Building Inspection Report

FANGS BUILDING INSPECTIONS

John St, Burwood East, VIC, 3151

Report/Agreement # 06121903003263

DPC Not Placed Properly

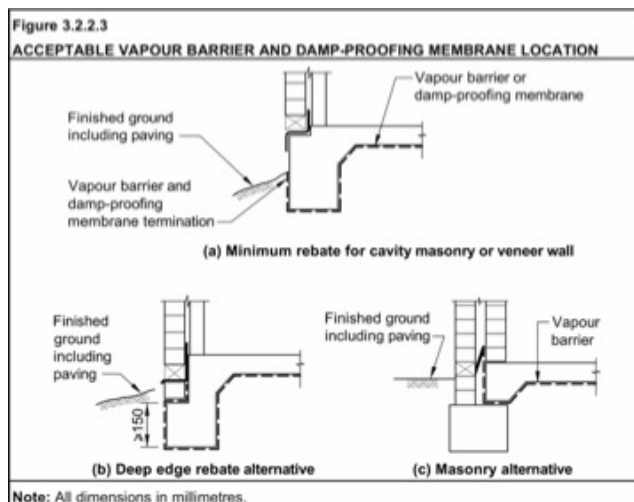
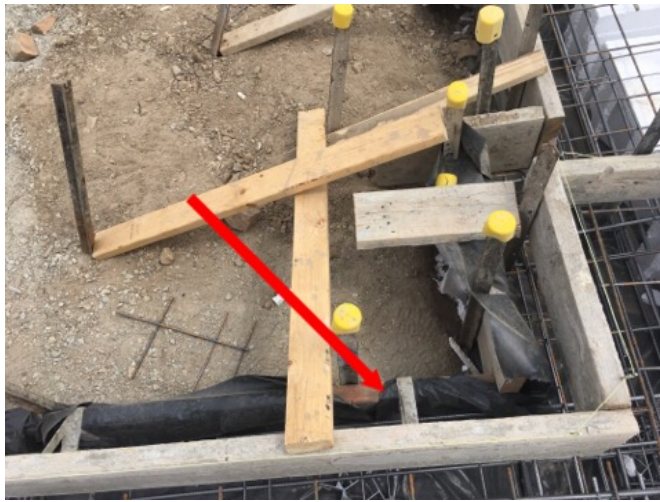
The relevant Australian Standard AS 2870 Slab & Footing Construction, clause 5.3.3 Vapour Barriers and Damp-proofing Membranes, requires that 'Vapour barriers shall be installed so that the bottom surface of the slab and beams, including internal beams, is entirely underlaid. The membrane shall extend under the edge beam to ground level.'

(ii) tape or seal with a close fitting sleeve around all service penetrations; and the vapour barrier membrane in this area will need to be properly extended, lapped and sealed

Bar Chairs 30mm Clearance Not Achieved

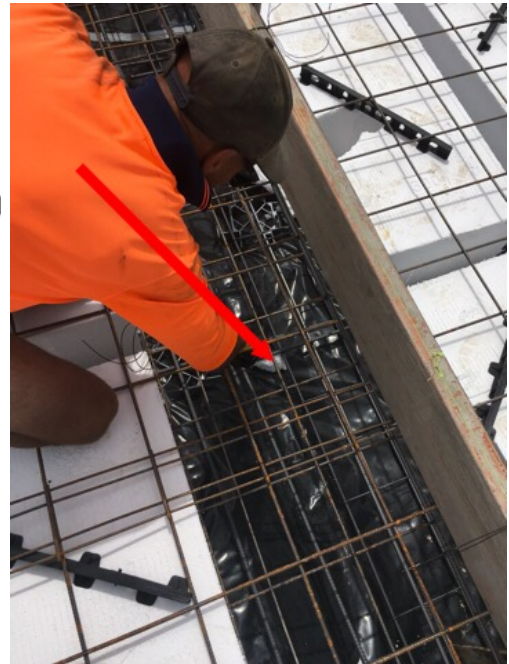
Bar chairs are not placed in right order, 30mm clearance must be provided as per BCA Section 3 3.2.3.2 (d)

(ii)30 mm to a membrane in contact with the ground."

Extra Support Not Provided Around Pipes

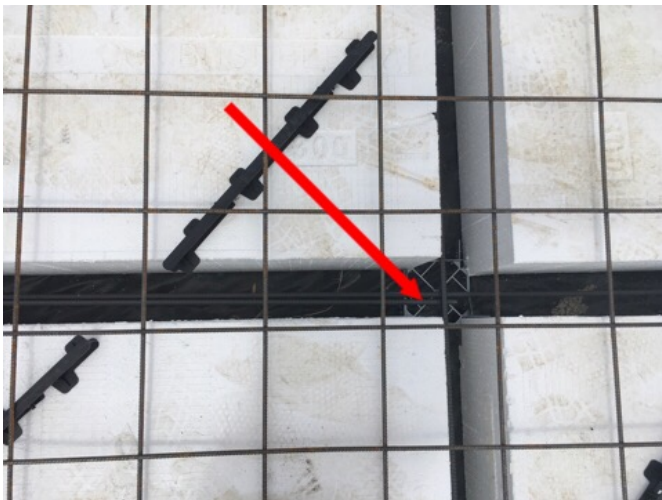
Additional reinforcing bars are required to be installed around pipe.

Pipe Lagging Missing

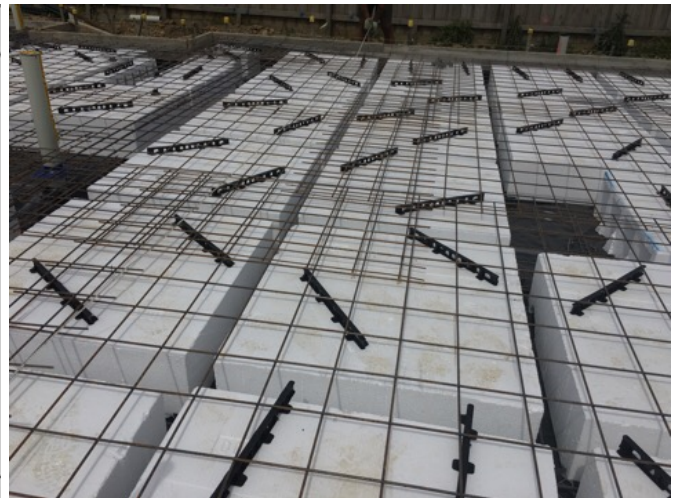
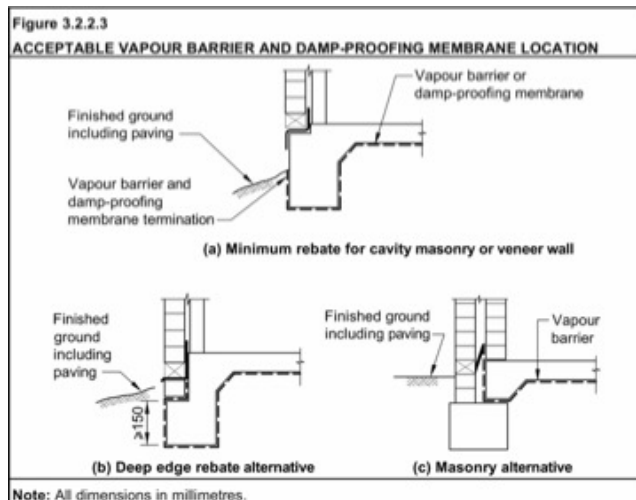
Pipe laggings are missing and must be installed before concrete pouring
